Knox County Procurement Division Addendum I to Invitation for Bid 3538 Innovative School Model Renovations – Phase 2

ADDENDUM #01

Project Name: Project No:	Knox County Schools ISM Phase 02 DIA_22100
Date:	March 28, 2024
To:	All Bidding Contractors of Record
Owner:	Knox County Schools Attention: Knox County Procurement Division 1000 N. Central Street, Suite 100 Knoxville, TN 37917
Architect:	Design Innovation (DIA) 402 S. Gay Street, Suite 201 Knoxville, TN 37902

-			EXISTING EXTERIOR DOWNLIGHT
D			WITH BATTERY BACK-UP TO REMAIN
С			
-			
в			
-			
A	5	CANOPY PLAN - LIGHTING

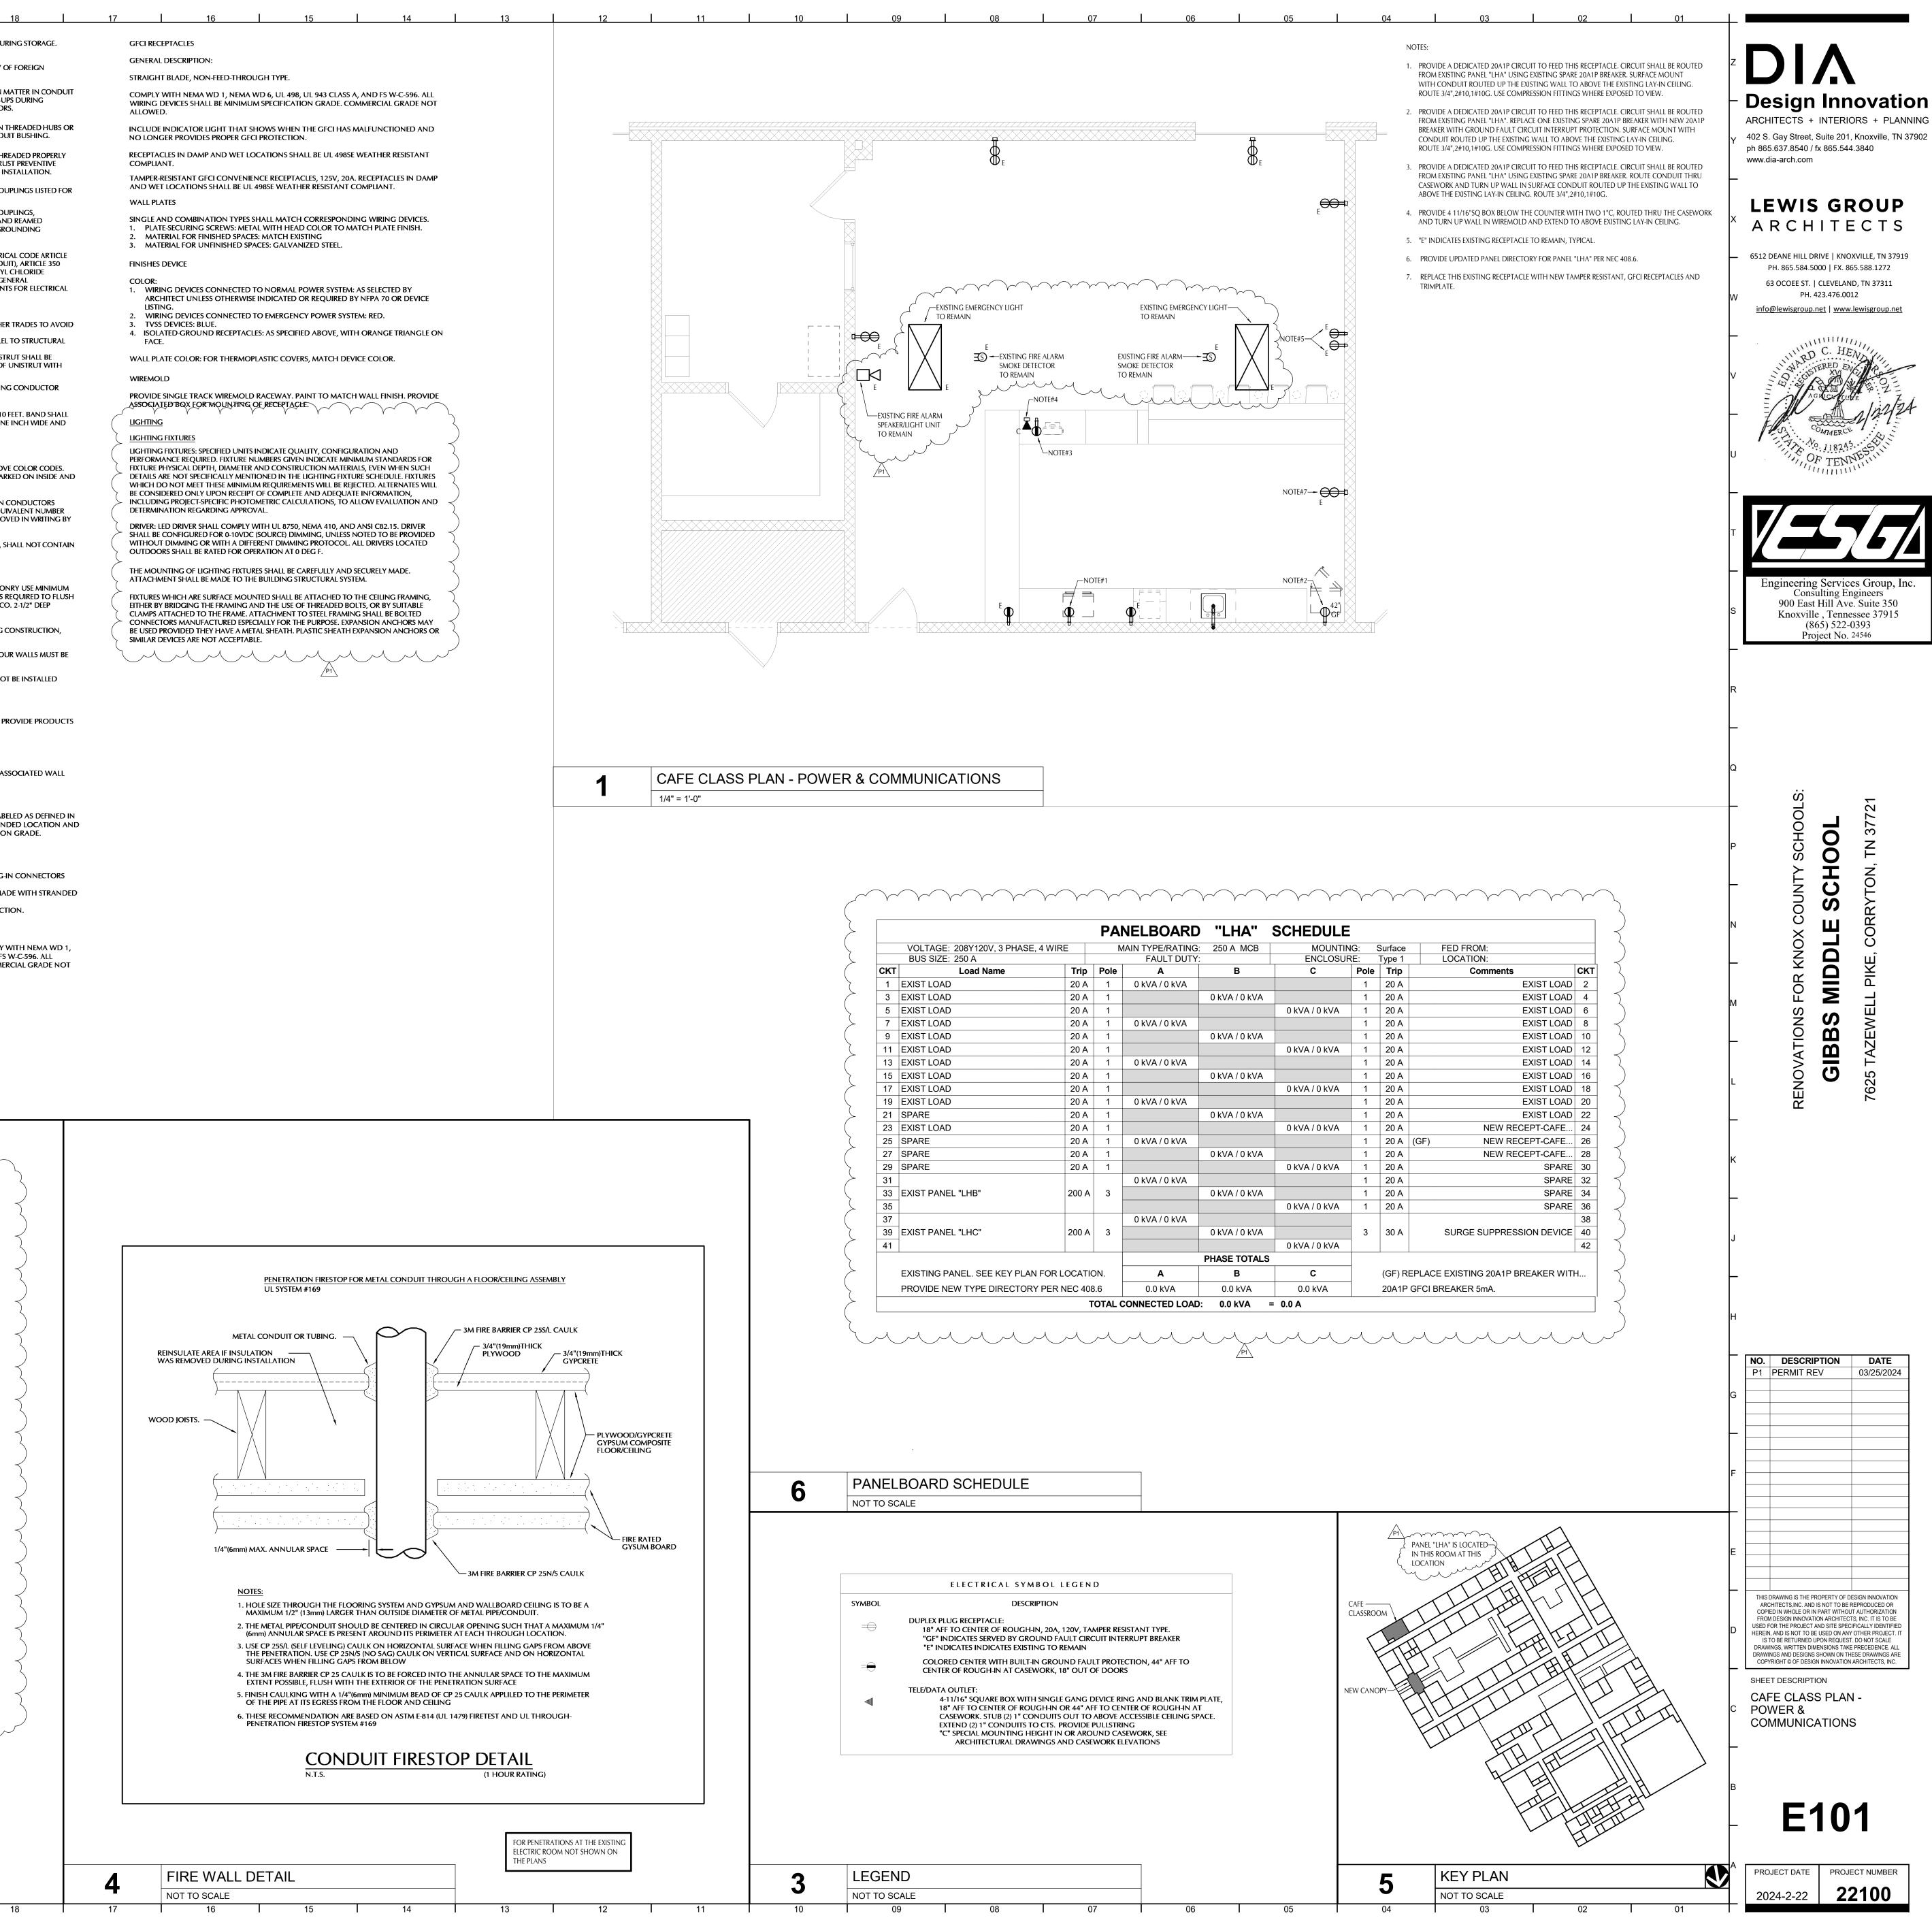
11. Gibbs Middle School, sheet E101, added canopy lights, updated panel board.
